BZA Case# 03-2009

210 S. Poplar

City of Oxford
Inter-Office Review Transmittal Sheet

BZA-03-2009 – 210 S. Poplar, Variance to Section 1141.03(e)(4)Principal Entrance and Section 1141.03(j) Residential Building Additions, Scott Webb, Applicant, Agent

SITE PLAN
1" = 20'-0"
SHOWING ADDITION OF 2-STORY DWELLING UNIT TO AN
EXISTING SINGLE FAMILY RESIDENCE, CREATING A
2-FAMILY RESIDENCE IN THE R2MS ZONING DISTRICT
SURVEY INFORMATION FROM: BAYER BECKER
EXISTING SITE PLAN OF 210 SOUTH POPLAR, LOT #139
9/05/08

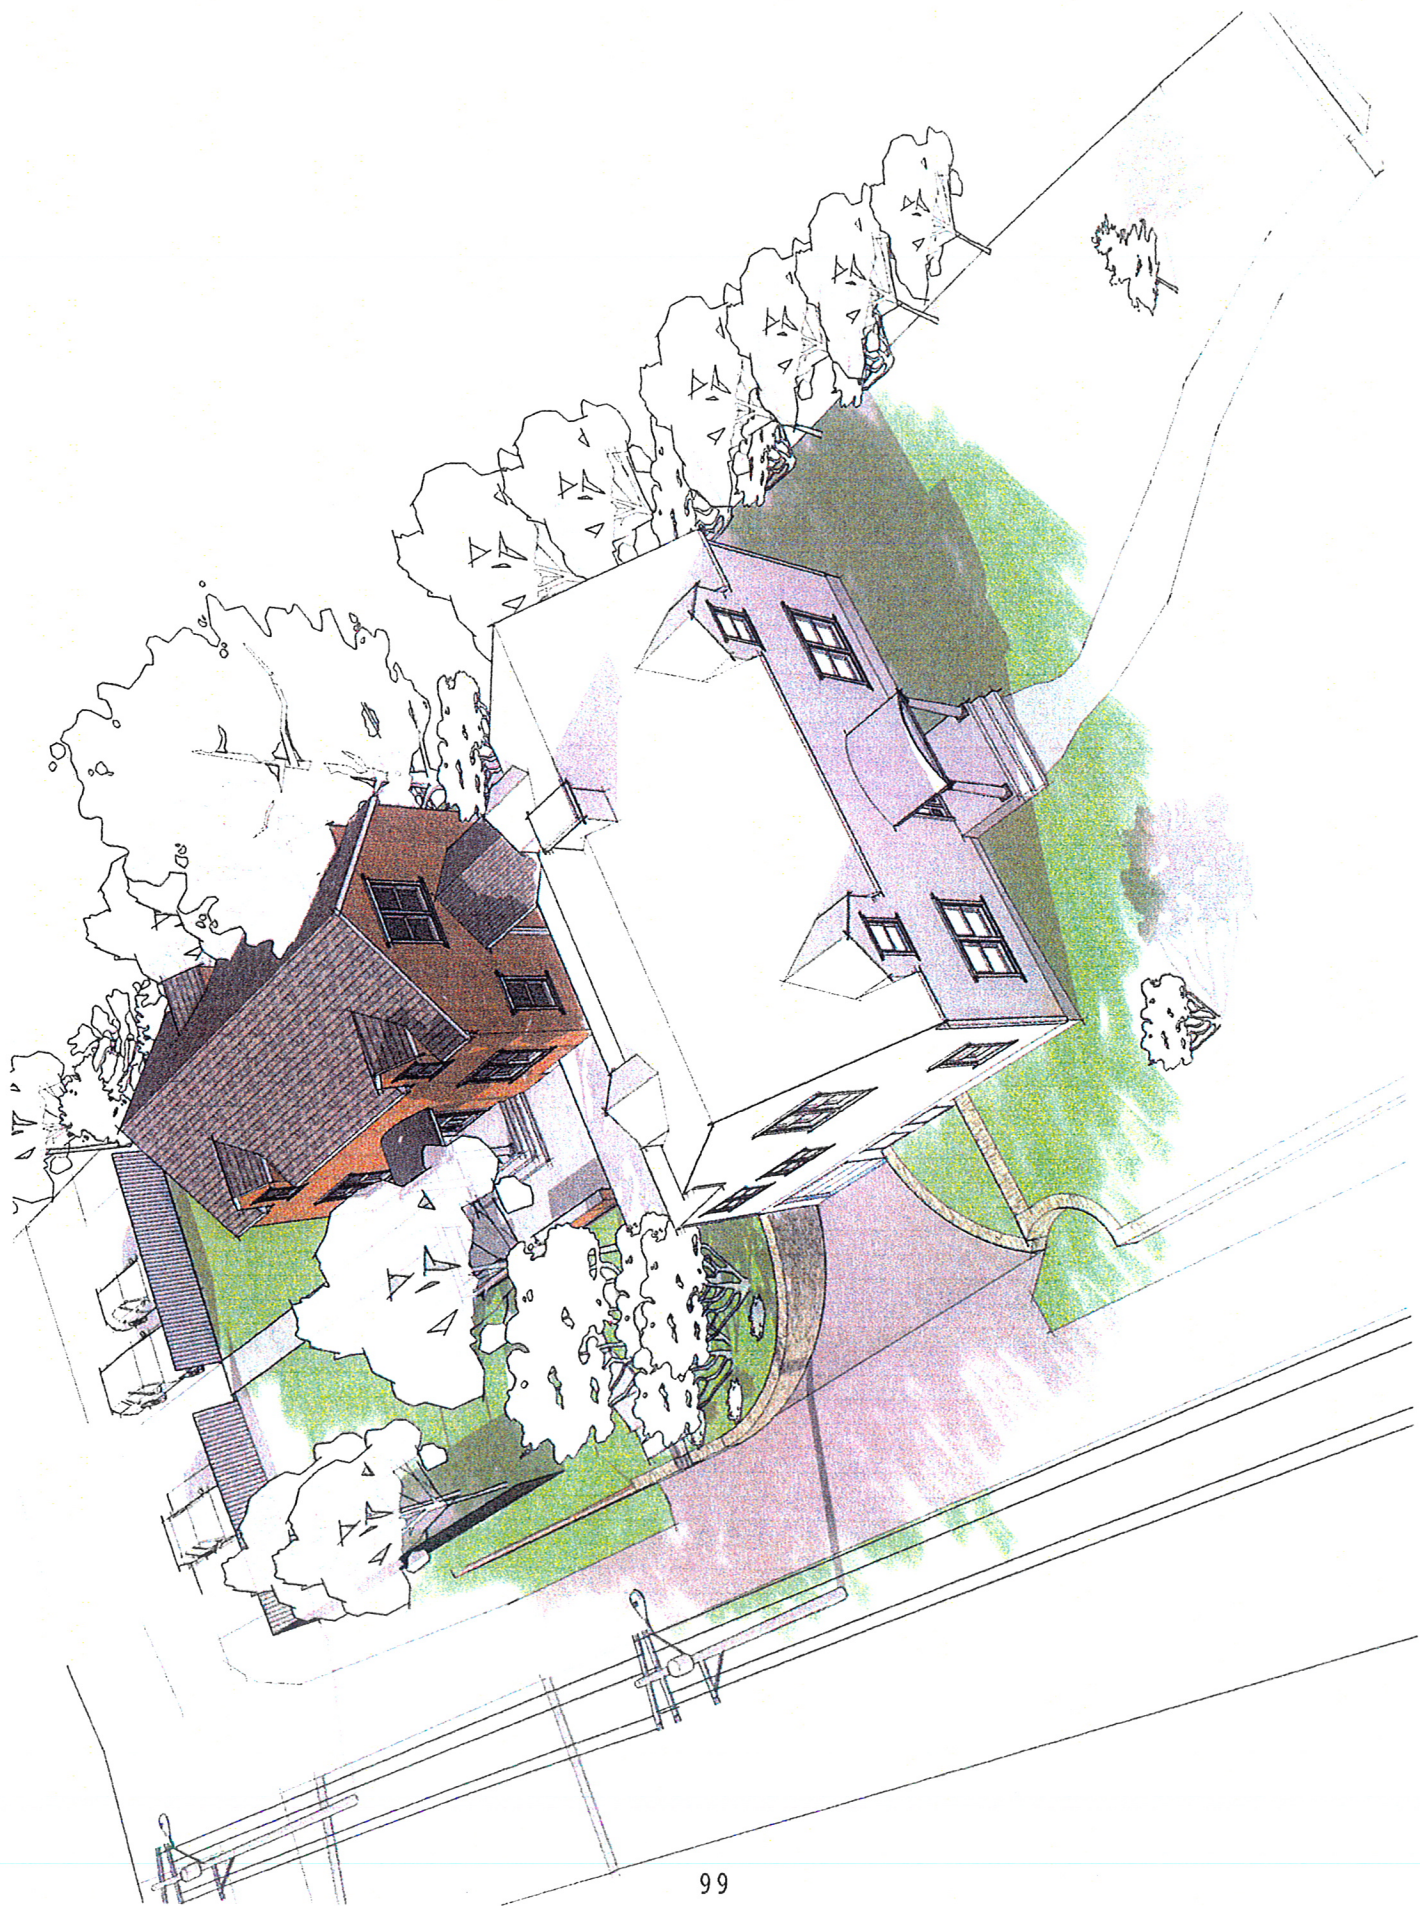
Interesting definition of a principal building. Connecting buildings with breezeways and, ultimately, consolidating lots, the entire city could become a principal building.

To build a new building and connect it to the existing building, then call the two combined buildings the "principal building" is beyond the grasp of logic for this simple police officer.
